# Neal Smith Engineering, Inc.

Structural Inspection 387 Gainsborough Lane Cameron, North Carolina NSE Project #2100625

387 Gainsborough Lane Cameron, North Carolina NSE Project #2100625

$\underline{\underline{Photo}\,\#2}$  – A double 2X joist was lag bolted into the existing house band board. The bolts averaged 4'-6" on center.

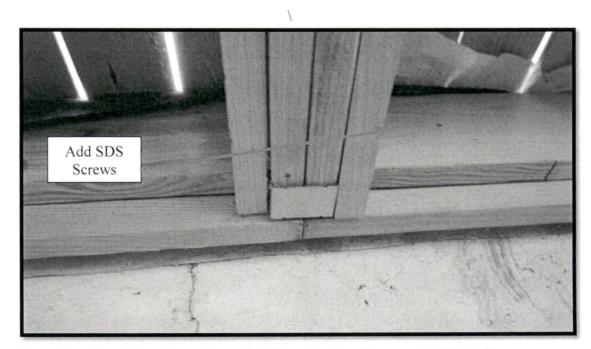
Photo #3 – The girders framed into the 2X band with a Simpson LU210-2 clip.

The lag bolts at the girder connection are inadequate. Add (3)  $\frac{1}{4}$  x 6" Simpson SDS screws on each side of the girder. Another option is to provide (1)  $\frac{5}{8}$ " galvanized through bolt on each side at each girder location. The end girders will only have  $\frac{1}{2}$  the screws or bolts, they also only have  $\frac{1}{2}$  the load.

Screws have been added to the above subject project per the recommendation in **NSE's** report dated September 7, 2021, and no further repairs are required.
